UNITED STATES
DEPARTMENT OF THE INTERIOR
BUREAU OF LAND MANAGEMENT
Sundry Notices and Reports on Wells

PLUG AND ABANDONMENT PROCEDURE

Escrito Gallup Unit #20

Re: Permanent Abandonment
Well: 20 Escrito Gallup Unit

Proposed P&A

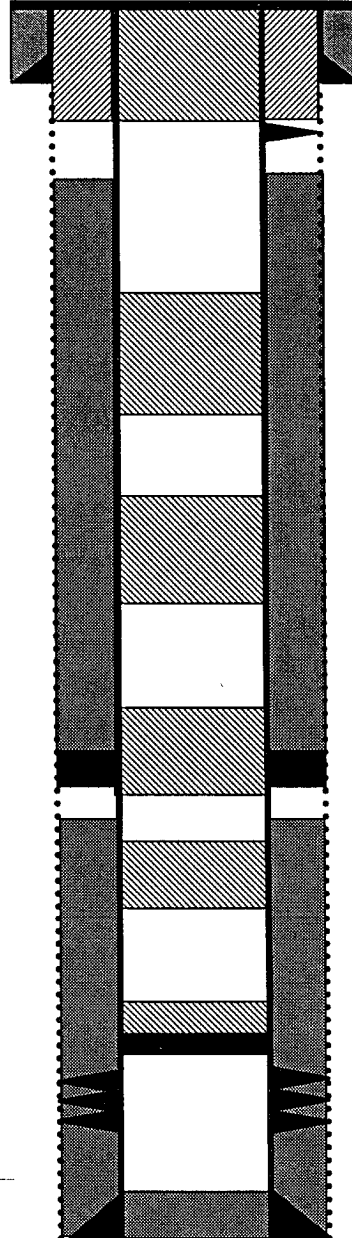
~~3173~~ ~~3073~~
5. **Plug #2 (Mesaverde top, ~~3910'~~ – ~~3810'~~)**: Mix 12 sxs Class G cement and spot a balanced plug inside casing to cover the Mesaverde top. PUH.

~~2800~~ ~~2700~~
6. **Plug #3 (Chacra top, ~~3277'~~ – ~~3177'~~)**: Mix 12 sxs Class G cement and spot a balanced plug inside casing to cover the Chacra top. PUH.

3. The following modifications to your plugging program are to be made:

a) Place the Mesaverde plug from 3173' – 3073'.

b) Place the Chacra plug from 2800' - 2700'.

Note: Chacra plug is unnecessary.
